Wollongong Local Planning Panel Assessment Report | 19 July 2022

WLPP No.	Item No.1
DA No.	DA-2021/1308
Proposal	Demolition of existing structures, construction of a five (5) storey residential flat building comprising 13 residential units over two (2) levels of basement car parking
Property	30 Bourke Street, North Wollongong - Lot 3 DP 37711
Applicant	PRD Architects
Responsible Team	Development Assessment and Certification - City Centre & Major Development Team (TW)
Prior WLPP meeting	N/A

ASSESSMENT REPORT AND RECOMMENDATION

Figure 2 - extract of building section illustrating those components of the building which breach the 16m height plane.

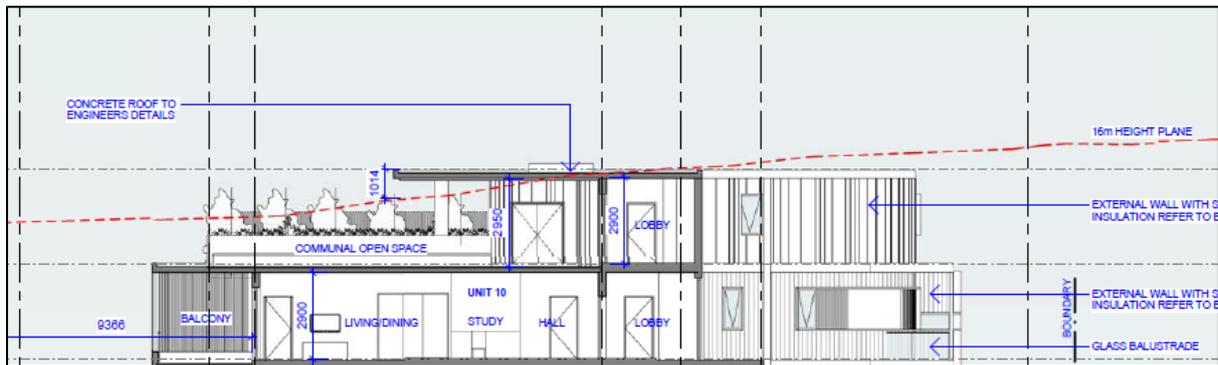
The height of buildings map prescribes a maximum building height of 16m for the site. The proposed maximum height is 17.014m which exceeds the height limit by 1.014m which represents a variation of ~6%. The applicant has sought a departure from the standard in accordance with Clause 4.6 of the LEP; this is addressed below. The height exceedance relates to a portion of the lift overrun and the roof over the communal open space. This is illustrated in the below section of the upper floors of the building, with the red hatched line depicting the 16m height limit.

WLEP 2009 Clause 4.6 proposed development departure assessment – Building Height	
Development departure	Clause 4.3 Building Height –17.014m proposed; this exceeds the height limit of 16m by 1.014m, or ~6%.
Is the planning control in question a development standard	Yes

1 GROUND FLOOR PLAN
1 : 100

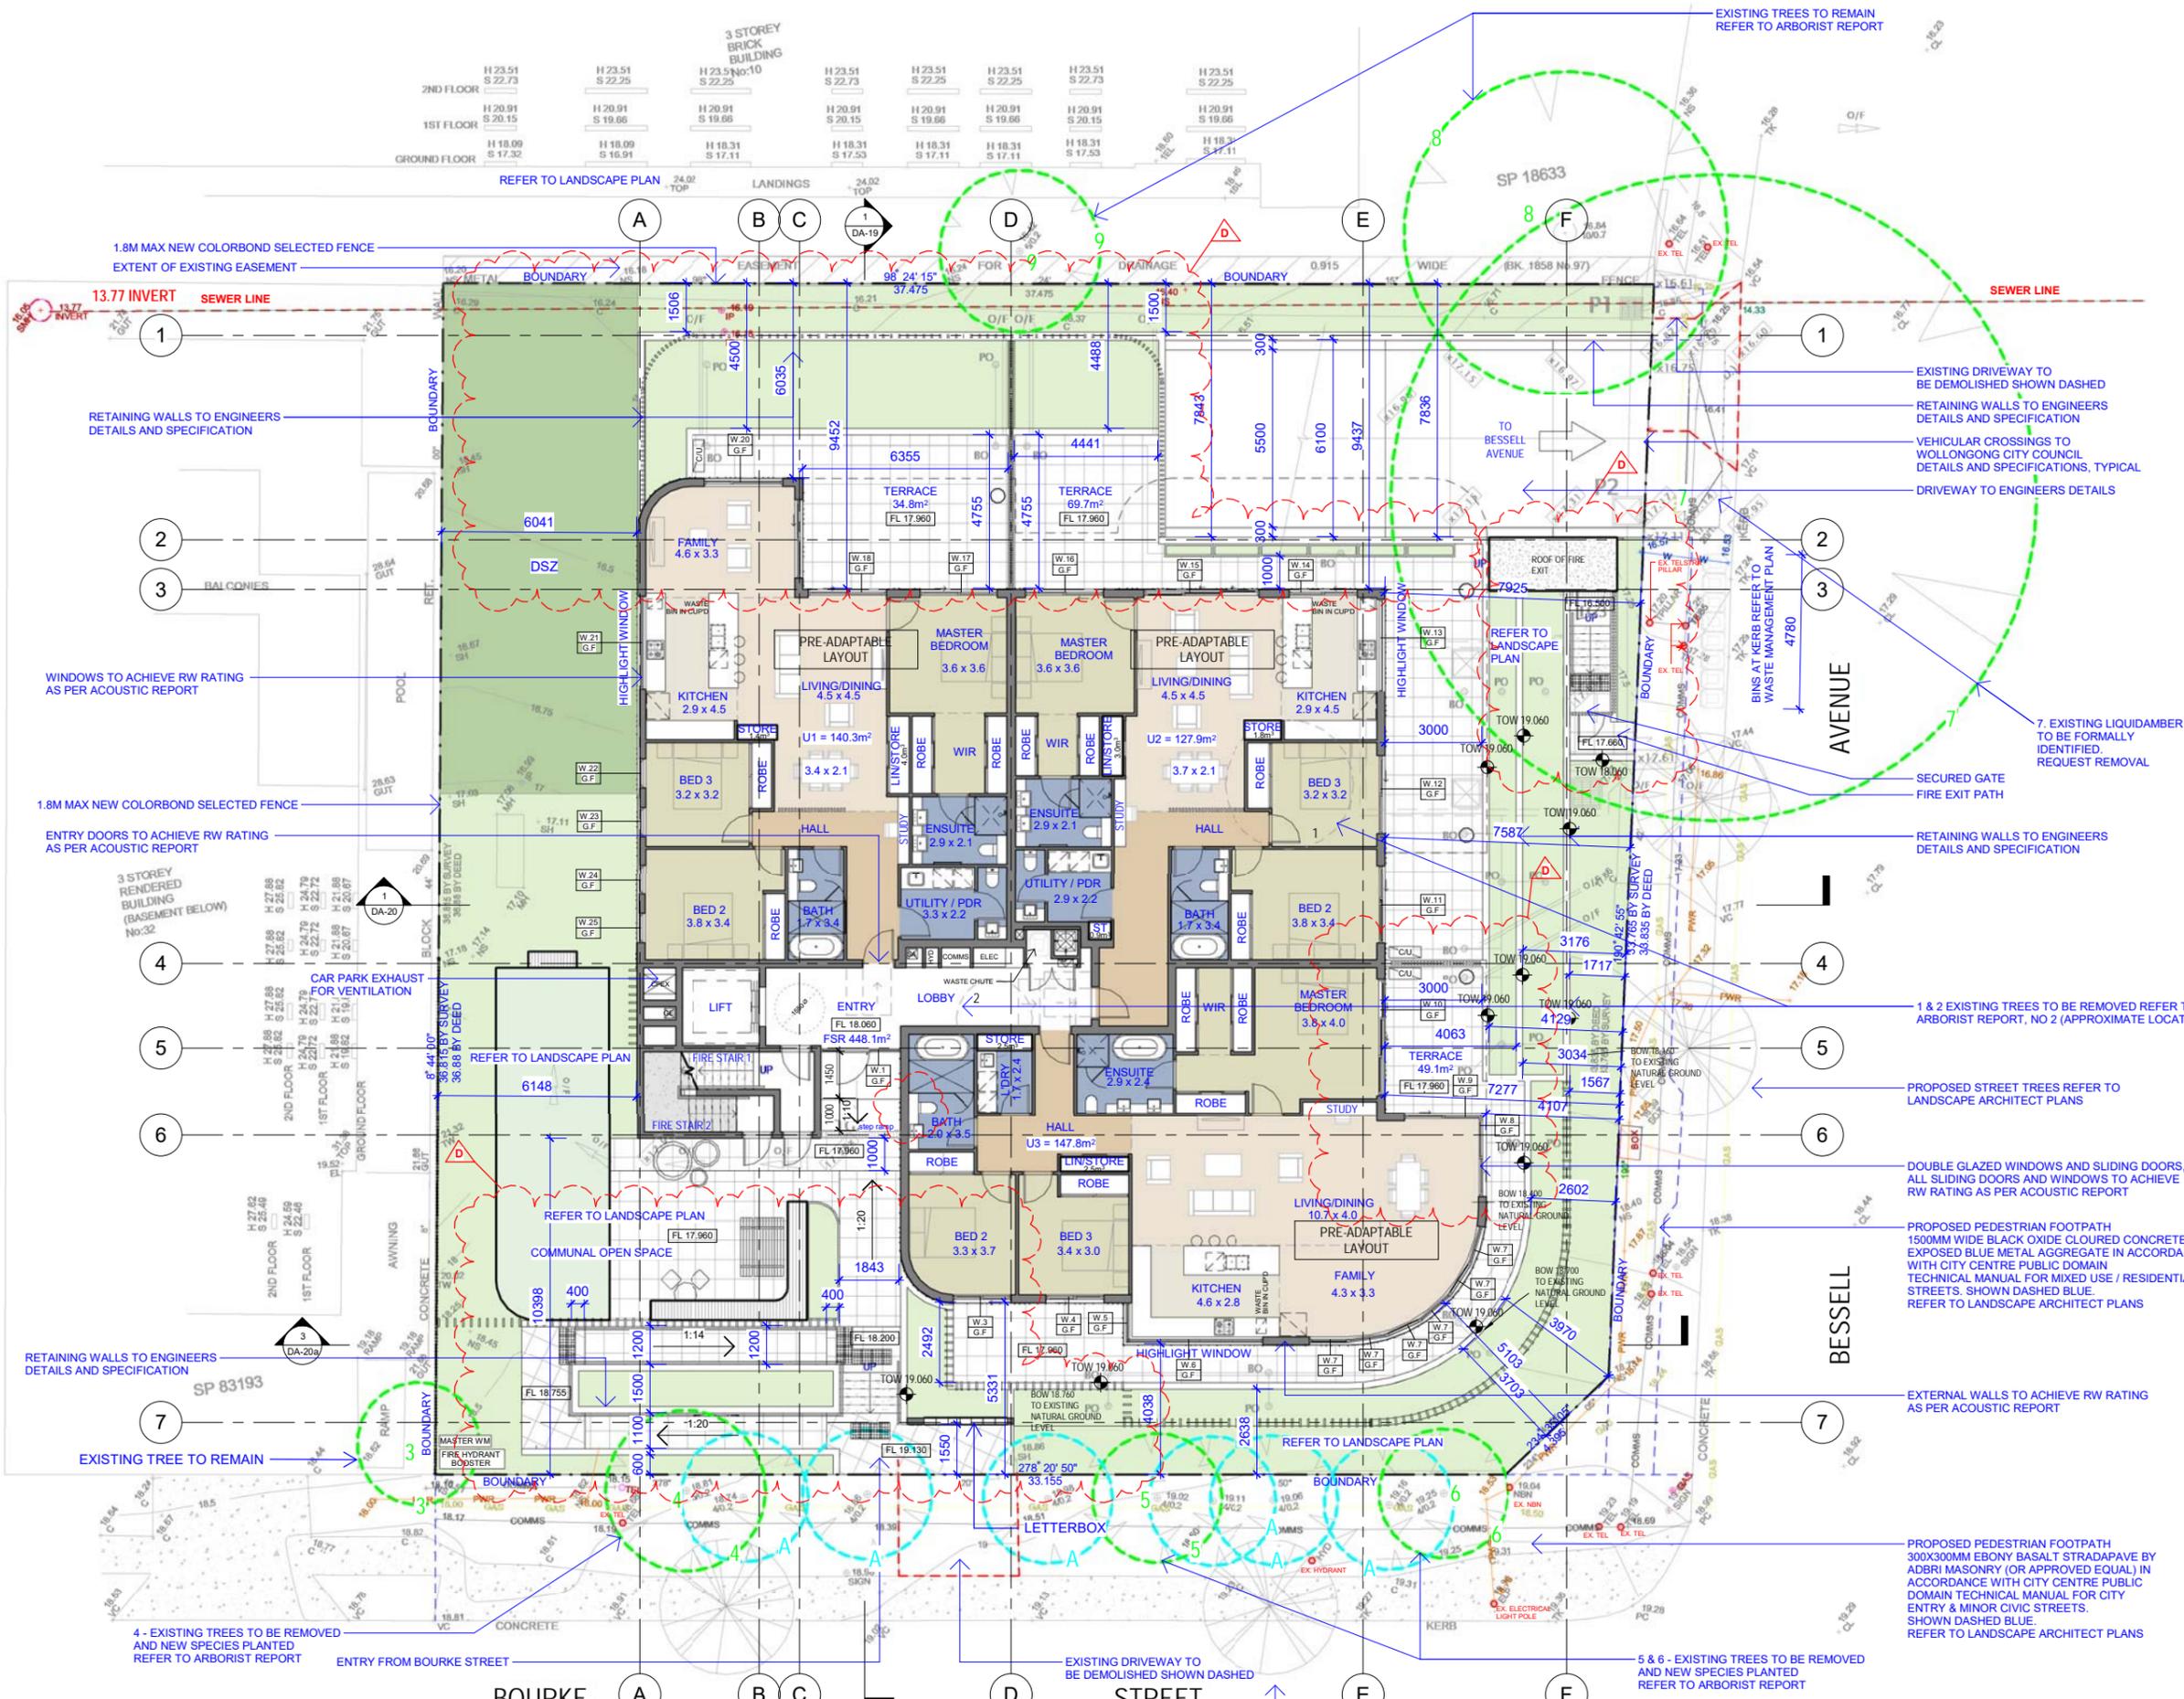
- The ground floor entryway has become more convoluted and less resolved. Further redesign is required.
- Further details of the screens / landscaping to be provided between the entry path and the bedrooms of unit 3 to secure the privacy of the bedrooms. Screening is shown on the plans for Unit 3, however the "detailed section" depicts a block labelled privacy screen. This screen is 2060mm above the entryway at the point where the section is cut, but the pathway is higher at other points, likely meaning the privacy screen should go to the ceiling on the western edge to prevent privacy issues. Also, the screening seems to be spaced widely apart, which won't help much with privacy (and not shown in perspectives).

- Further detail in relation to the terraces of Units 1 and 2 which are located closer to the northern boundary and are approx. 1.5m above natural ground level. The proximity of the terrace to the open walkway of the neighbouring building could create privacy issues. While sections have been provided, these do not depict the walkway of the neighbouring residential flat building.

- Unit 2 northern terrace will be compromised by the location of the basement entry ramp. Council's Architect noted that a privacy screen is provided again to part of driveway and a very small planting bed which will provide no screening to the length of driveway.

1 HEIGHT PLANE ANALYSIS

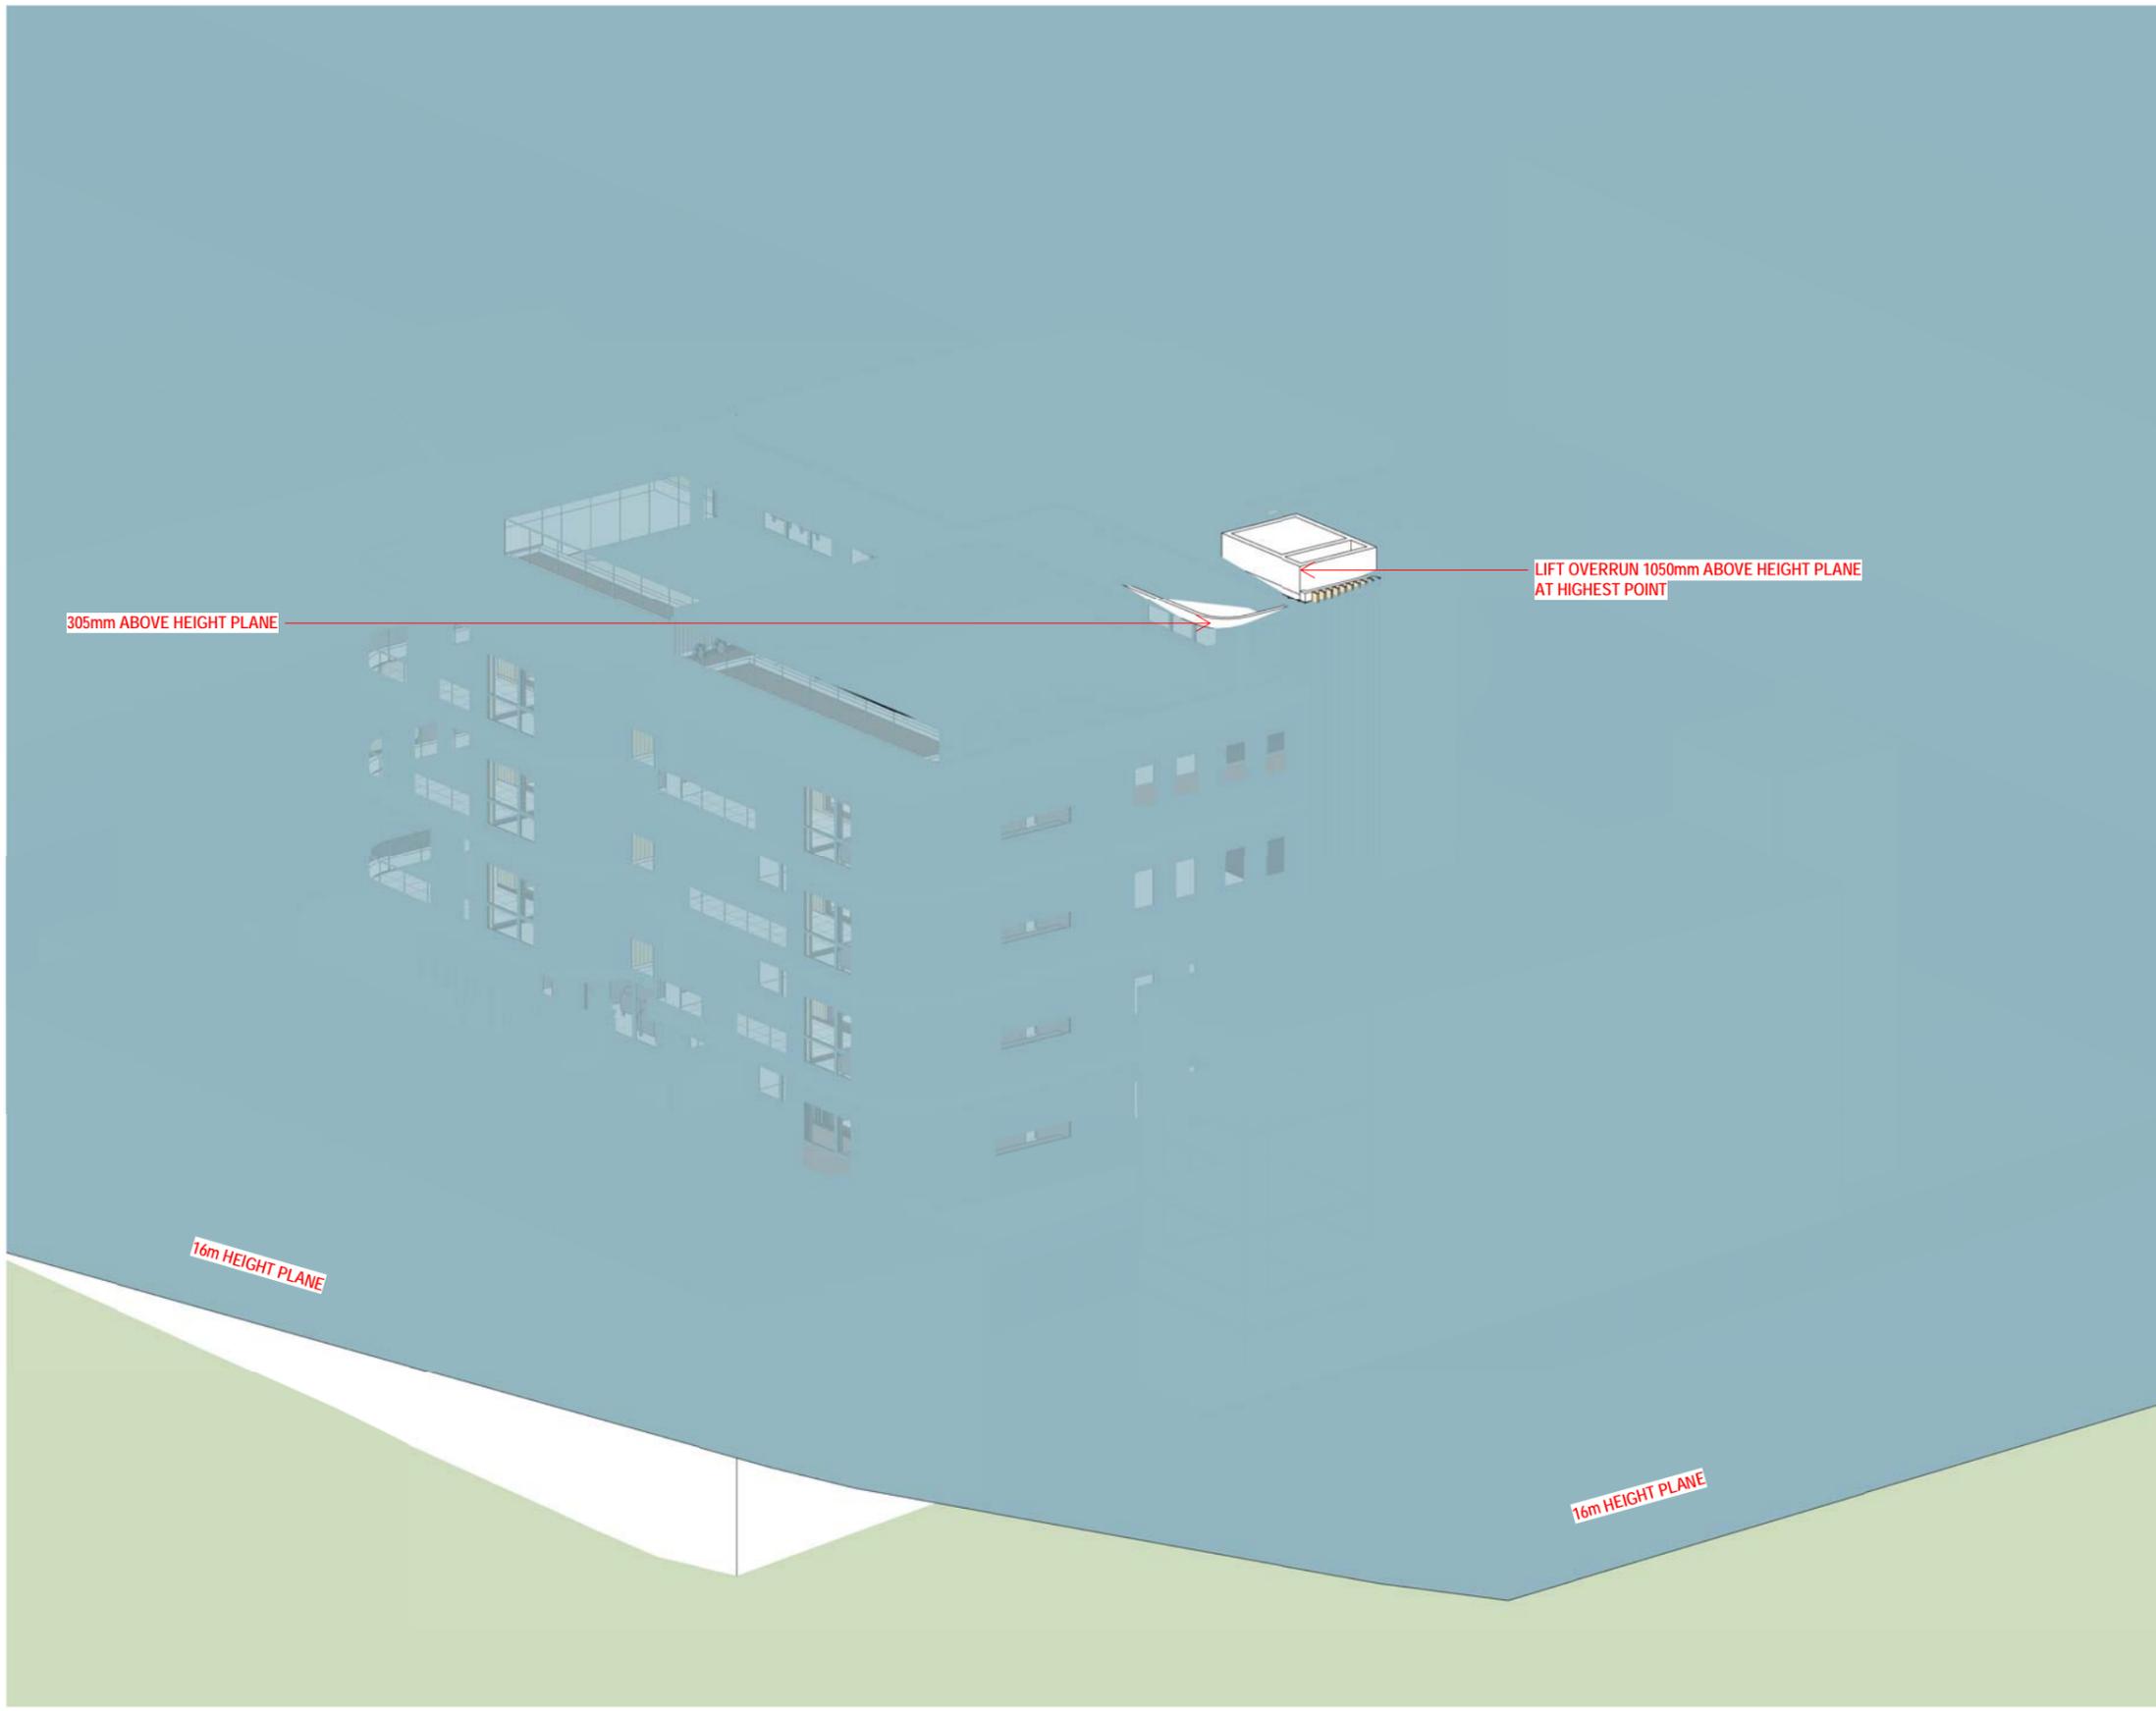
- The poor relationship between Unit 2's POS and the driveway entry ramp remains unresolved;
- Solar panels are required to be shown in elevation, height plane diagram and view analysis; these are likely to exacerbate the height breaches.

The statement provides insufficient justification for the departure. The need to provide access to rooftop communal open space is not sufficient justification for breaching the height plane. If a rooftop COS is proposed, it is expected that this space and access thereto is contained within the height plane. The statement also reports that the height standard has been abandoned; this claim is definitively refuted.
